Access Compliance Report

Public Rights-of-Way

(Curb Ramps)

Intersection ID: 16048	Main Street: OXFORD_PL	Cross Street: PROVIDENCE_RD	Location: SW
ADA ID: 44E349AA1071	Ramp Type: Perp	Initial Pass/Fail: Fail	Overall Compliance: No
Severity Score: 35			
Codes/Mitigation Info/Possible Solution		Field Measurements/Component Compliance

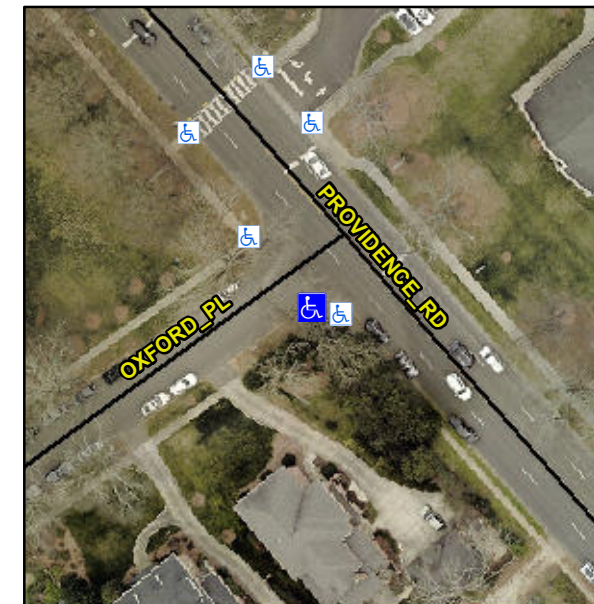
Not Found, R304.5.1, R304.2.2, R304.5.3

Compliance	Description	Data	Compliance	Description	Data
N/A	Ramp Length (in)	40.0	No	Ramp Slope (%)	14.9
No	Ramp Width (in)	47.0	No	Ramp XSlope (%)	2.7
N/A	Flare Type LT	N/A	N/A	Flare Type RT	N/A
N/A	Flare Slope LT (%)	N/A	N/A	Flare Slope RT (%)	N/A
N/A	Flare Traversable LT?	N/A	N/A	Flare Traversable RT?	N/A
N/A	Landing Length (in)	N/A	N/A	DWS Provided?	N/A
N/A	Landing Width (in)	N/A	N/A	DWS Contrast?	N/A
N/A	Landing Slope (%)	N/A	N/A	DWS Length (in)	N/A
N/A	Landing X Slope (%)	N/A	N/A	DWS Full Width?	N/A
N/A	Landing Curb? (Y/N)	N/A	N/A	DWS Offset (in)	N/A
N/A	Shared Landing?	N/A			
N/A	Gutter Ponding?	N/A	N/A	Gutter Slope (%)	N/A
N/A	Gutter Lip Ht (in)	N/A	N/A	Gutter X Slope (%)	N/A
N/A	Painted X Walk1?	No	N/A	Painted X Walk2?	N/A
	X Walk 1 Direction	To NW		X Walk 2 Direction	N/A
N/A	X Walk 1 Width (in)	N/A	N/A	X Walk 2 Width (in)	N/A
	X Walk 1 Slope (%)	2.8		X Walk 2 Slope (%)	N/A
	X Walk 1 X Slope (%)	2.3		X Walk 2 X Slope (%)	N/A

Remove & Replace Entire Ramp.
